Access Compliance Report

Public Rights-of-Way

Intersection ID: 49293	Main Street: ELIZABETH_CREST_LN	Cross Street: CHAMBERLIN_RD	Location: SW
ADA ID: B50ABD52AC6E	Ramp Type: PerpDiag	Initial Pass/Fail: Pass	Overall Compliance: No
Severity Score: 0			
Codes/Mitigation Info/Possible Solution		Field Measurements/Component Compliance

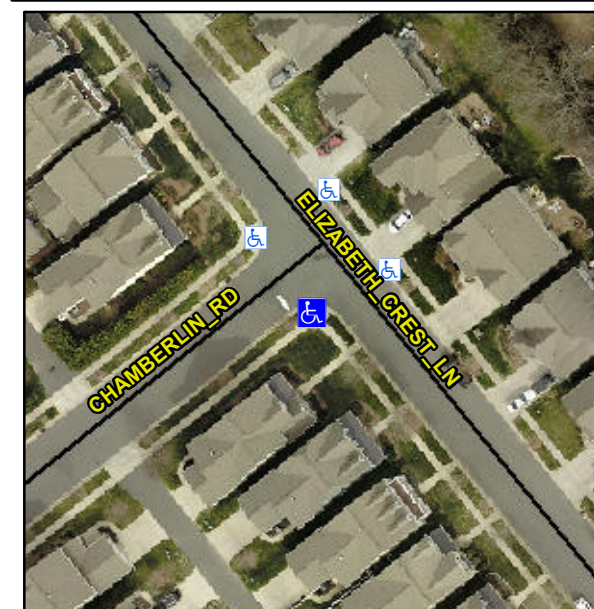
Not Found, R304.2.2-Perp, R304.3.2-Para, R304.5.3

Compliance	Description	Data	Compliance	Description	Data
N/A	Ramp Length (in)	74.0	Yes	Ramp Slope (%)	6.6
Yes	Ramp Width (in)	48.0	Yes	Ramp XSlope (%)	1.9
N/A	Flare Type LT	Sloped	N/A	Flare Type RT	N/A
N/A	Flare Slope LT (%)	8.1	Yes	Flare Slope RT (%)	3.7
N/A	Flare Traversable LT?	Yes	N/A	Flare Traversable RT?	Yes
Yes	Landing Length (in)	48.0	Yes	DWS Provided?	Yes
Yes	Landing Width (in)	48.0	Yes	DWS Contrast?	Yes
No	Landing Slope (%)	2.2	Yes	DWS Length (in)	24.5
No	Landing X Slope (%)	4.0	Yes	DWS Full Width?	Yes
N/A	Landing Curb? (Y/N)	No	Yes	DWS Offset (in)	2.0
N/A	Shared Landing?	No			
Yes	Gutter Ponding?	No	Yes	Gutter Slope (%)	1.0
Yes	Gutter Lip Ht (in)	0.0	No	Gutter X Slope (%)	3.0
N/A	Painted X Walk1?	No	N/A	Painted X Walk2?	No
	X Walk 1 Direction	To NE		X Walk 2 Direction	To NW
N/A	X Walk 1 Width (in)	N/A	N/A	X Walk 2 Width (in)	N/A
	X Walk 1 Slope (%)	4.7		X Walk 2 Slope (%)	0.7
	X Walk 1 X Slope (%)	0.7		X Walk 2 X Slope (%)	2.8

Remove & Replace Curb Ramp With Two New Directional Ramps or Equivalent. Remove & Replace Gutter.
